20150217-5145 FERC PDF (Unofficial) 2/13/2015 5:16:27 PM

CO39 Continued, page 33 of 61

- CO39-29 The affected environmental and current conditions for all resources are discussed at considerable length for each resource in Chapter 4, as explained in section 4.0 (page 4-1) of the DEIS.
- CO39-30 Alternatives are considered in Chapter 3. See the introduction to that chapter for a discussion of how FERC addresses alternatives.

Figure 1. From Zhang (2012). NAVD88 is basically the level of Mean Higher High Water. The scale in meters translates as 10 m ~ 33 feet. North, West, etc are model estimates for water heights at three sides of the JCEP ship-loading basin.

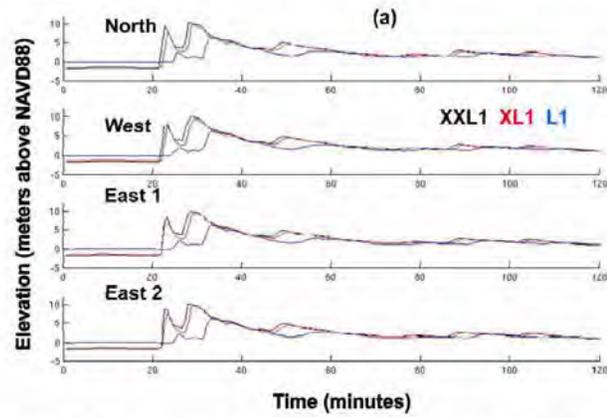
The Zhang model results are not explicitly shown in the DEIS. They are shown in attached Figure 1. The projected run-up amounts to about 10 m or +30 feet, which, apart from a +60 ft wall around the LNG storage tanks, is the tsunami from which the design engineers hope to protect the terminal and power plant. While this is a solid analysis so far as it goes, it does not go nearly far enough. Problems:

- (1) The model’s incoming wave rises from a high tidal stand, and then returns to it. Initial waves of real tsunami inside embayments like Coos Bay do arrive without much initial outflow (unlike on adjacent beaches), but they are followed by arrival of the tsunami wave trough, which can drop water level as far below the tidal stand as the initial wave was above it (Figure 2). Since the proposed LNG-carrier mooring basin will be only a few feet below carrier draft, a carrier will almost certainly be grounded, potentially damaging its hull, propellers and rudder.

- (3) Real tsunami sequences are not just one wave (Figure 1). That is admitted in the DEIS, to the extent that likely intervals to second and third waves, characterized as decreasingly great, are given (pages 4-244 & 245), though not shown in the Zhang model. After both the 1964 Alaskan and 2011 Tohoku, Japan, subduction earthquakes, the series of waves actually continued from 10 to 20 hours, wave after wave, often with the greatest amplitudes many hours into the sequence.
